TITLE: QUARTER PANEL SERVICE PART MODIFICATION

SECTION: EXTERIOR BULLETIN #162

MODELS: TOYOTA & LEXUS AS LISTED

DATE: FEBRUARY 2008

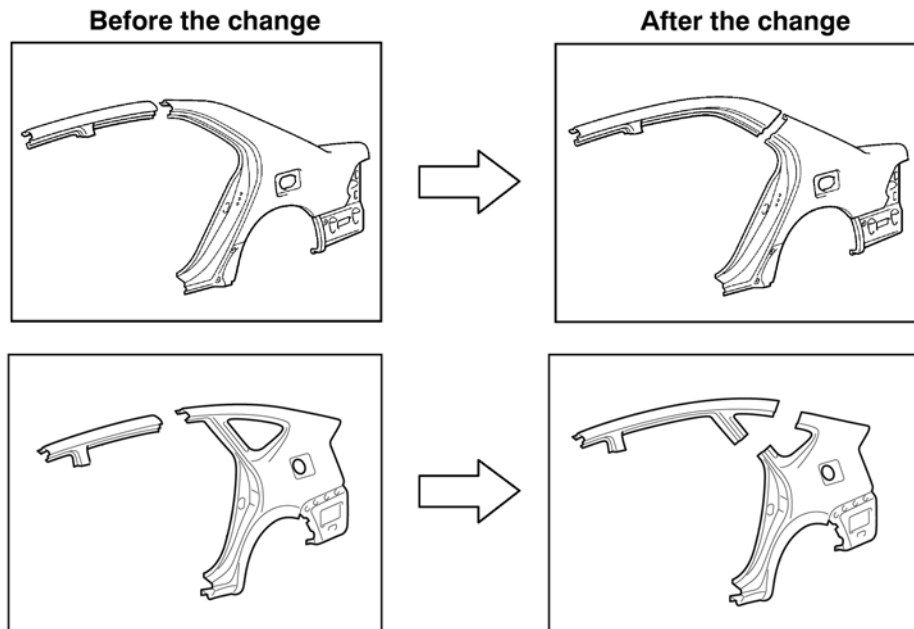
To improve storage and distribution logistics and reduce waste material, a change to Quarter Panel service part cuts have been made on select models. Implementation timing will vary due to number of in-stock units. Superseding part numbers will be issued as new stock arrives. The revised panel cuts are 50 mm in the roof direction from the specified cut-and-join location listed in Collision Damage Repair Manuals available from the Technical Information System (TIS) at ([www.techinfo.toyota.com](http://www.techinfo.toyota.com)). This revision does not represent any change to replacement specifications. Please refer to the illustrations and model-specific references below.
